ECE/TRANS/WP.29/2008/59  
10 April 2008

Proposal for Corrigendum 1 to Supplement 19 to the 04 series of amendments to  
Regulation No. 16  
(Safety-belts)

Submitted by the Working Party on Passive Safety (GRSP) \*/

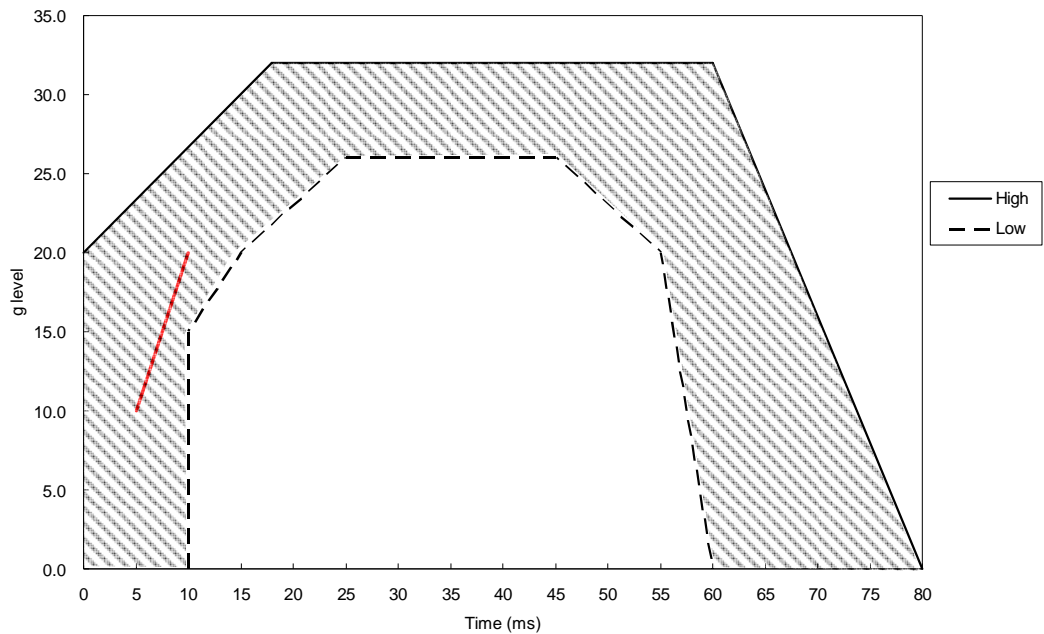
Annex 8, the figure, correct to read:
